49-A-1

2007-0157

165 Park Ave.

Sea Dogs Clubhouse

FRANK + LOUAY REVIEW

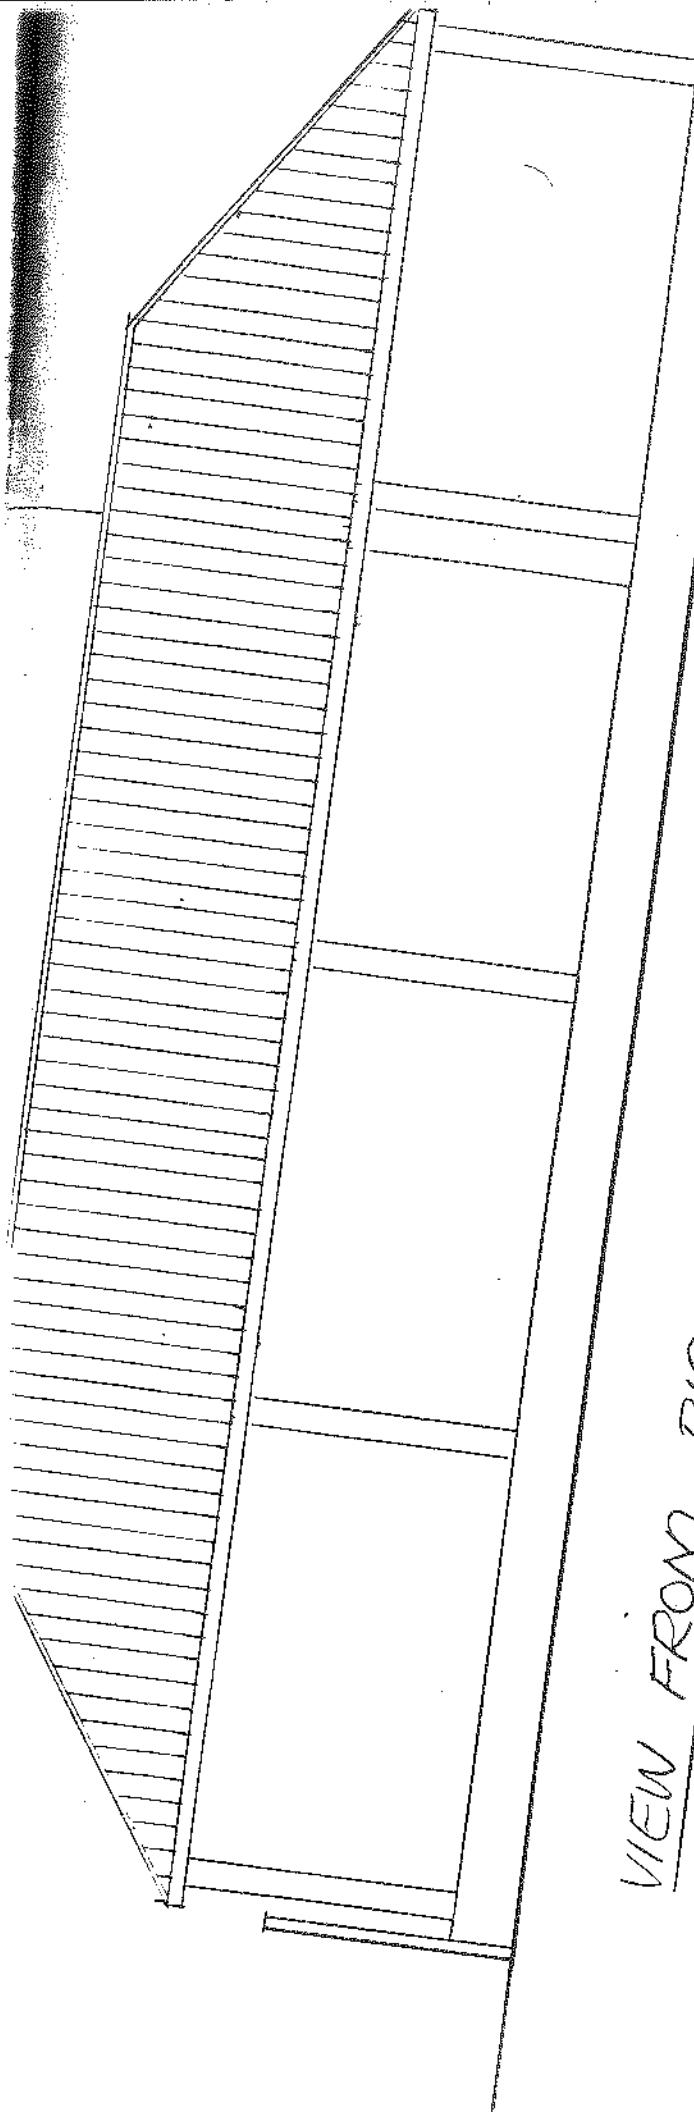
2 SCORBOANO ON PICNIC AREA IN JUVON

MATERIALS OF GEOGRAPHIC ENCLOSURE - NOT SHOWN ON THE ^{8. ELEVATION}

WHONG AND 3 PINE TREES BEING RELOCATED
